Re: Case No. 21-277-EL-BGN - In the Matter of the Application of Border Basin I, LLC for a Certificate of Environmental Compatibility and Public Need to Construct a Solar-Powered Electric Generation Facility in Hancock County, Ohio.

Response to Fifth Data Request from Staff of the Ohio Power Siting Board

**BORDER BASIN I, LLC'S
RESPONSE TO THE FIFTH DATA REQUEST
FROM THE STAFF OF THE OHIO POWER SITING BOARD**

Figure No.
4-1
Title
Project Constraints Map

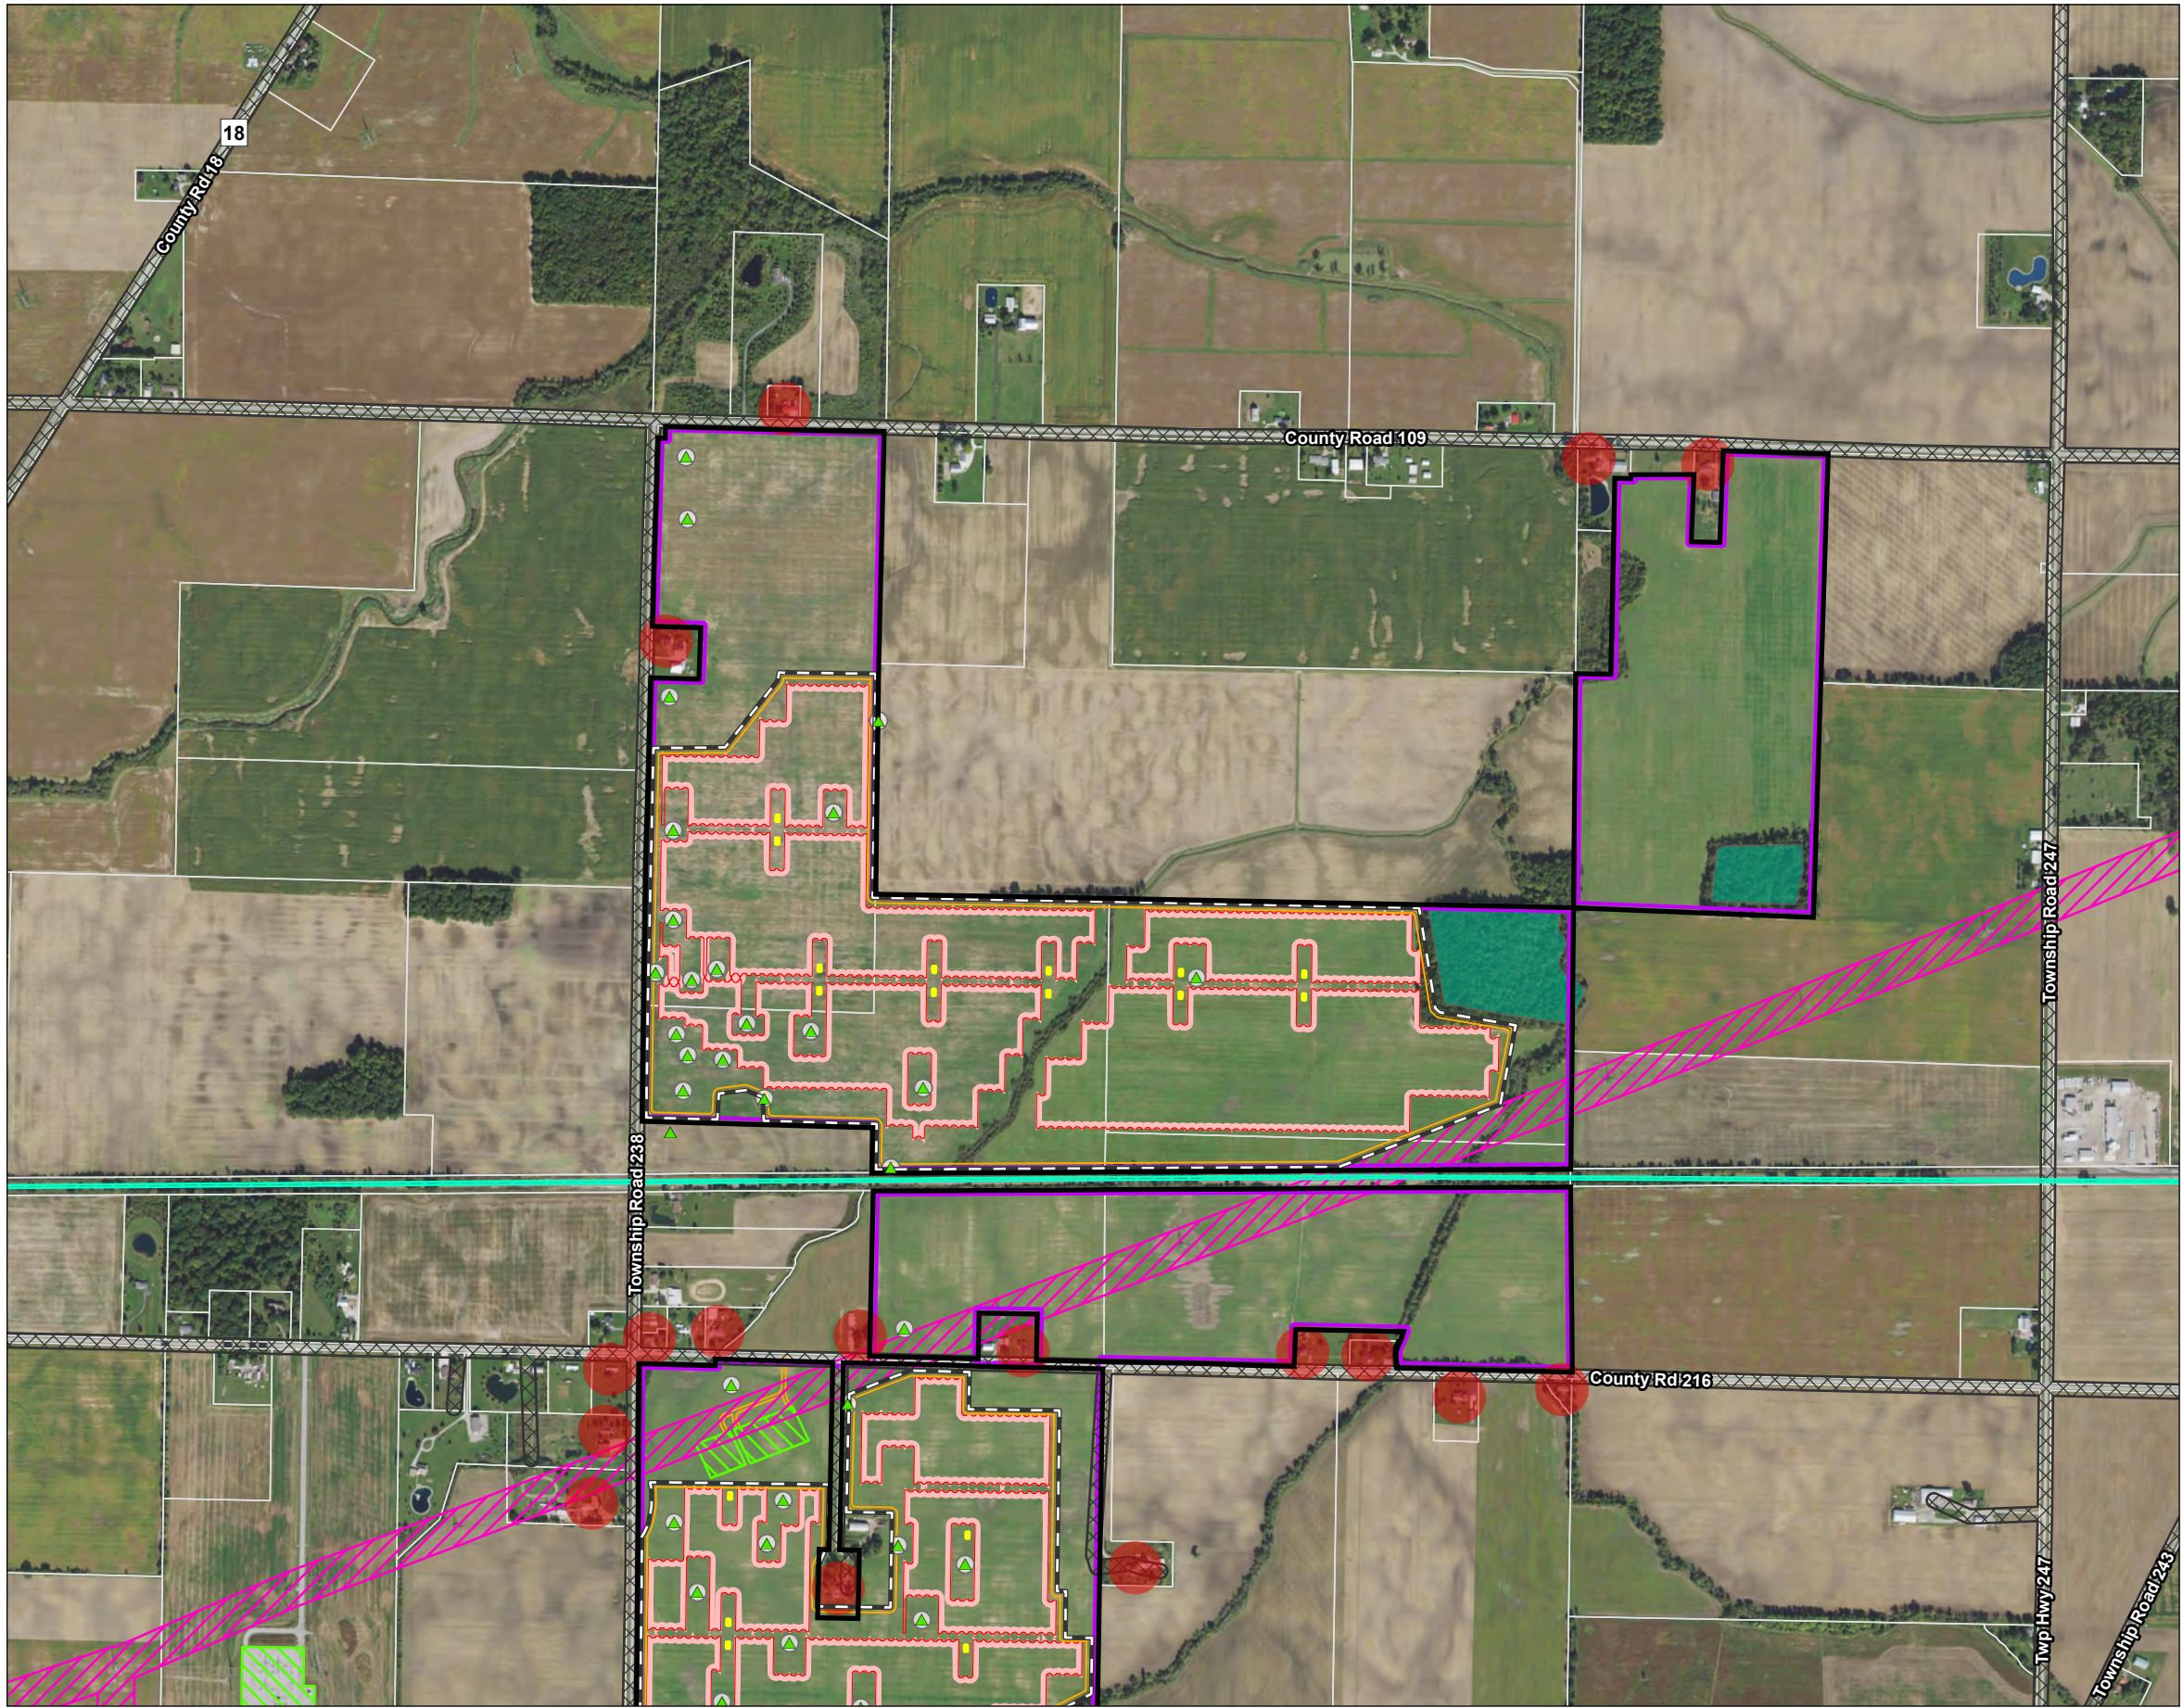
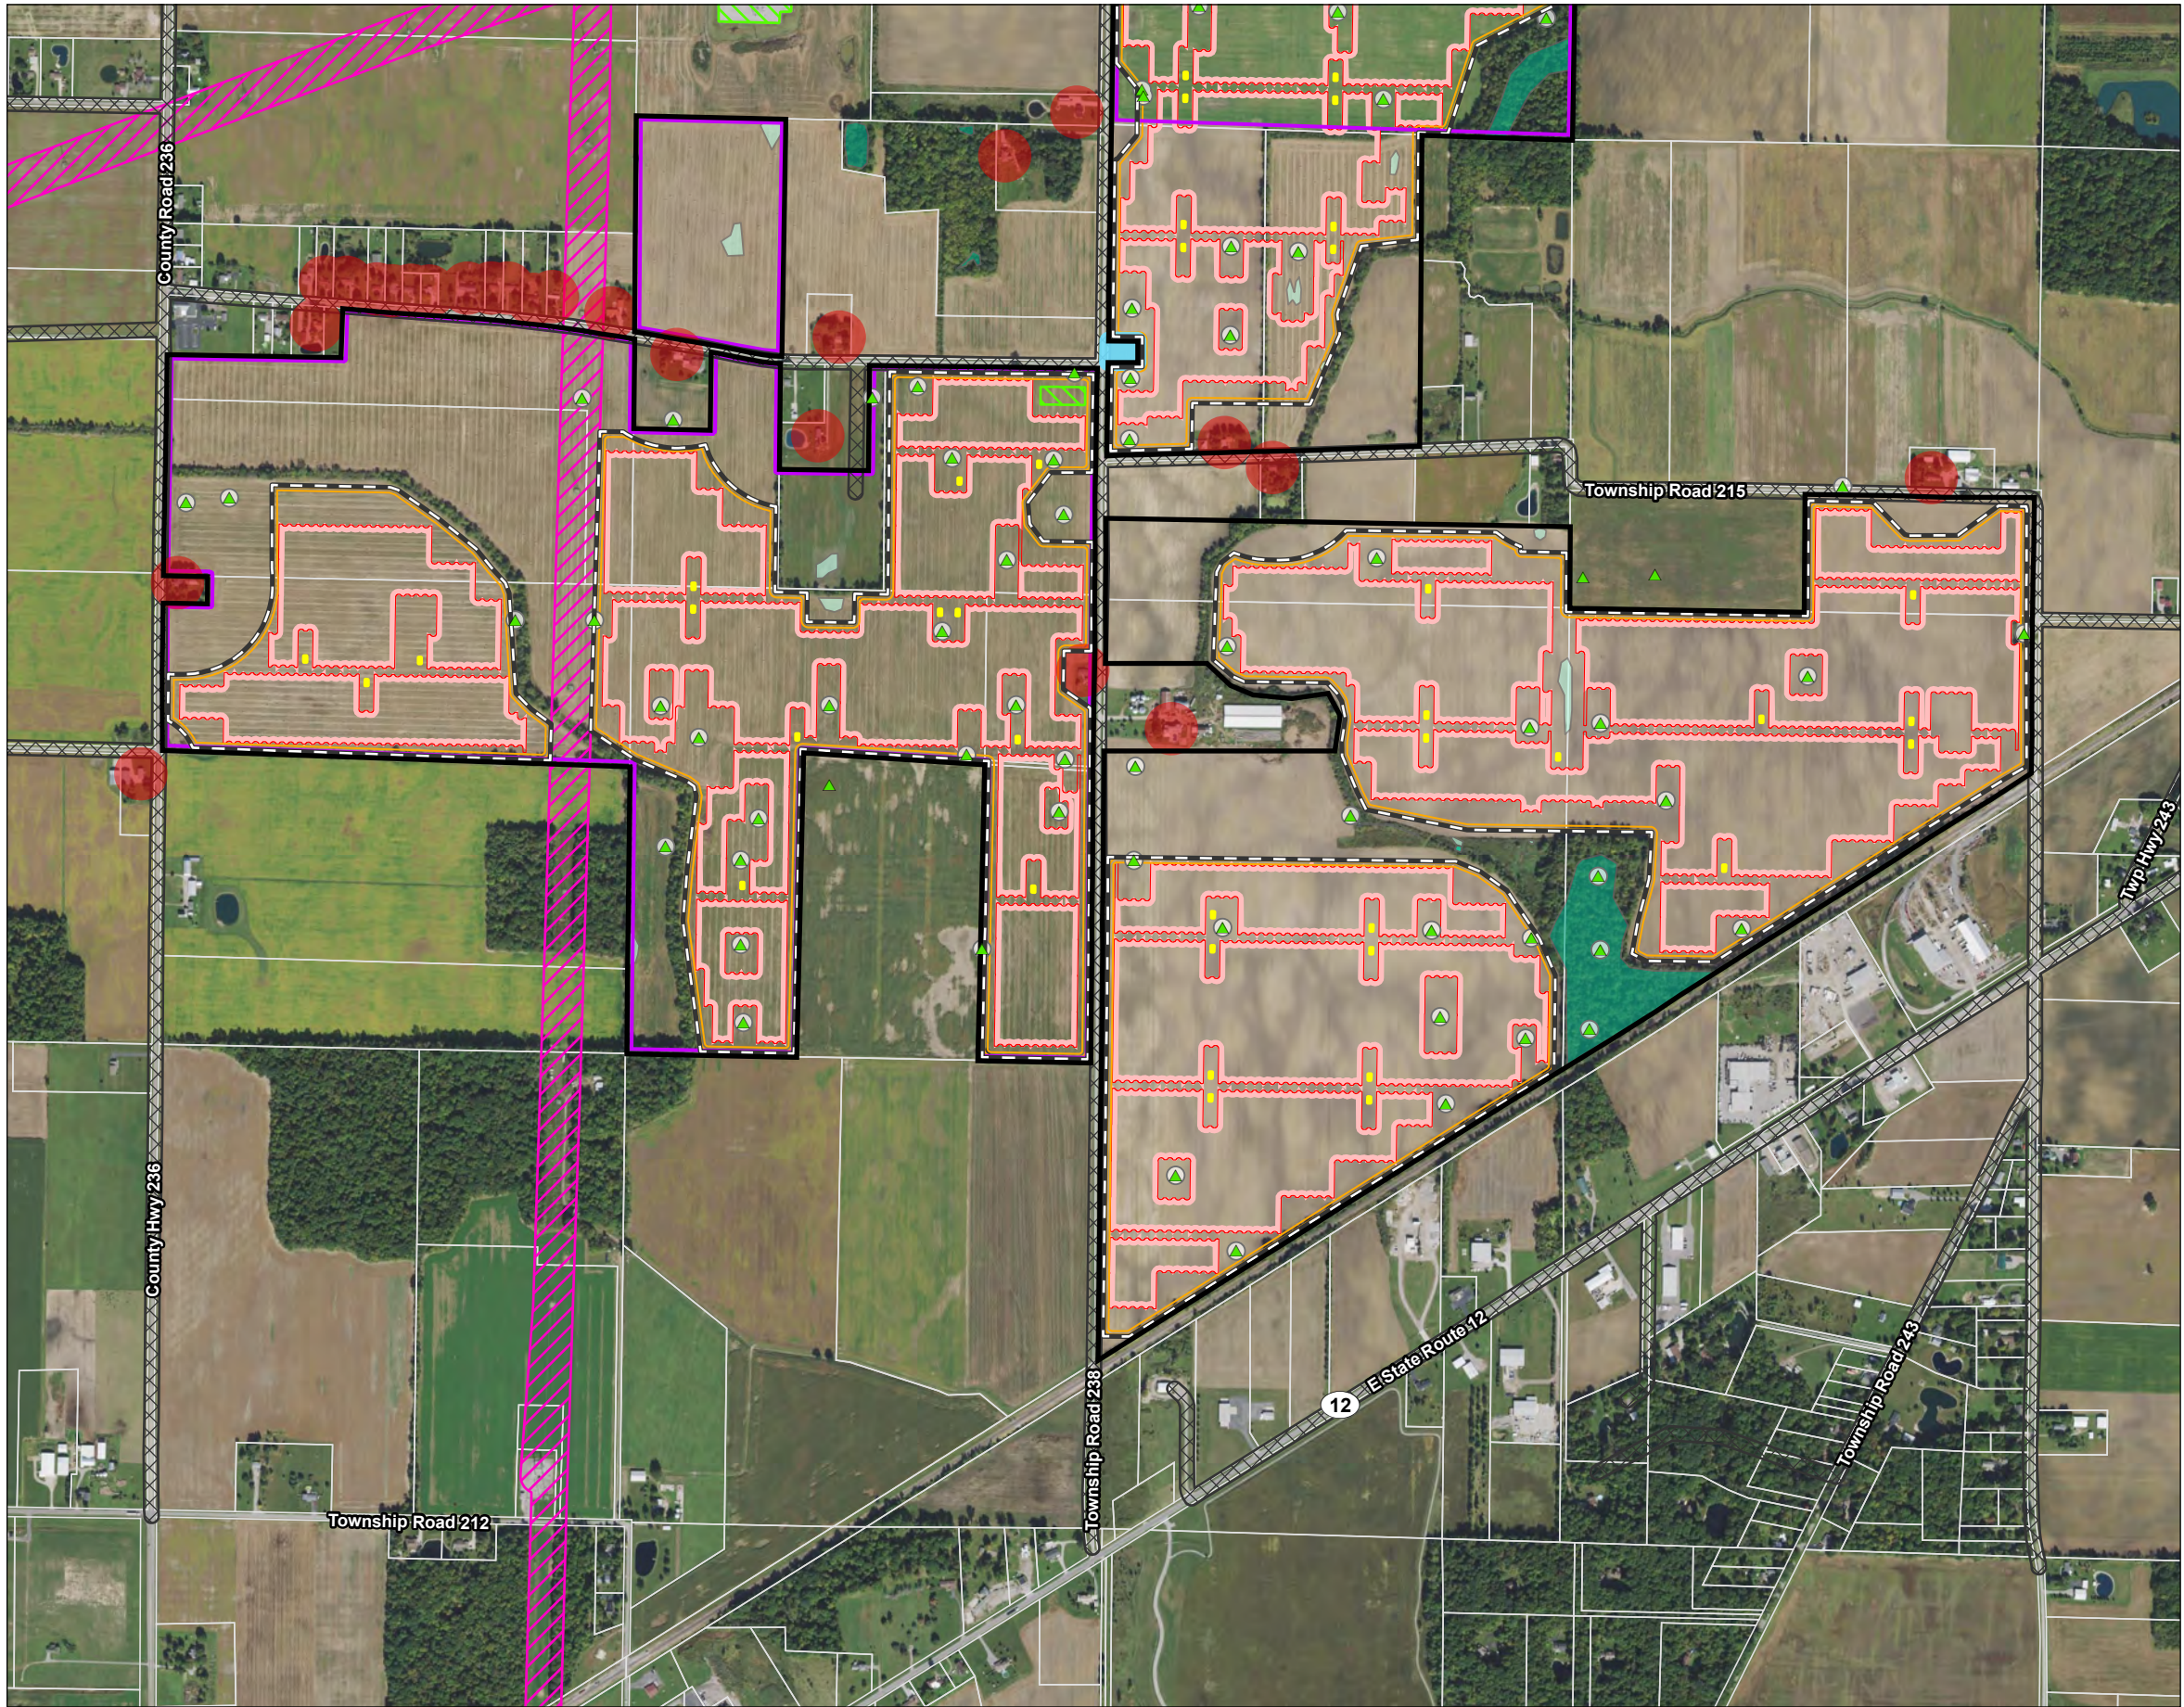
- Include a revised Figure 3-2 (Project Site Layout Map)
- Include a revised Figure 4-1 (Project Constraints Map)
- An explanation of what the Applicant would do if other oil/gas wells are encountered or found during construction;
- If the Applicant discovers the need to plug wells (prior to construction, during operation, or at the end of solar facility's life), include an analysis of the probable costs of construction or decommissioning; and
- Cost estimate to properly plug and abandon an oil/gas well.

Revised Figures 3-2 (Project Site Layout Map) and 4-1 (Projects Constraints Map) have been provided. These maps supersede all previous versions. In addition to the revisions that allow for a 50-foot or greater setback around each identified potential historical O&G well, the Project boundary has been updated to eliminate three parcels that are no longer part of the Project area. Removal of these three parcels does not alter any of the results nor conclusions of any of the studies or assessments included as part of the Application. The Project area now totals approximately 1,325 acres.

Figure 1

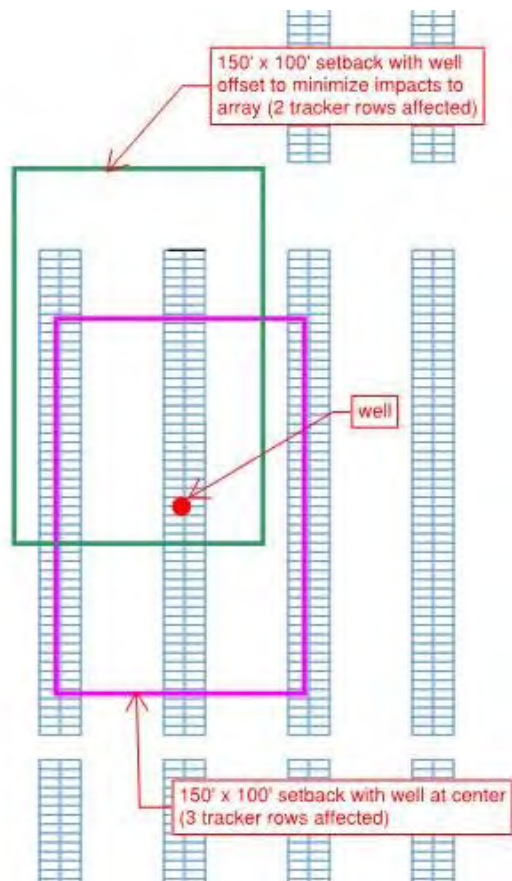
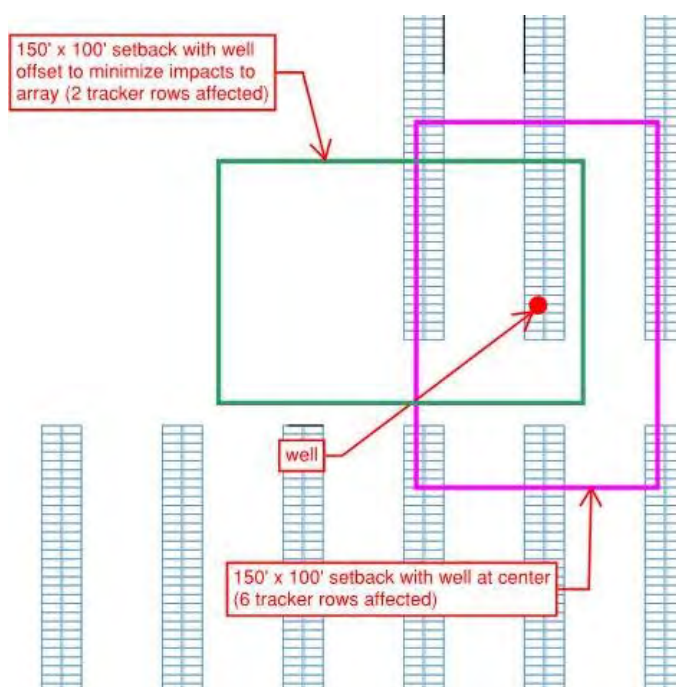
Wood understands that the 50 x 75-foot setback needed for plug truck access for the work required to plug the discovered does not need to be centered on the well itself. Figures 1 and 2 provide example setbacks and their tracker table impacts. If this is the case, the setback can be designed to impact the fewest strings based on the
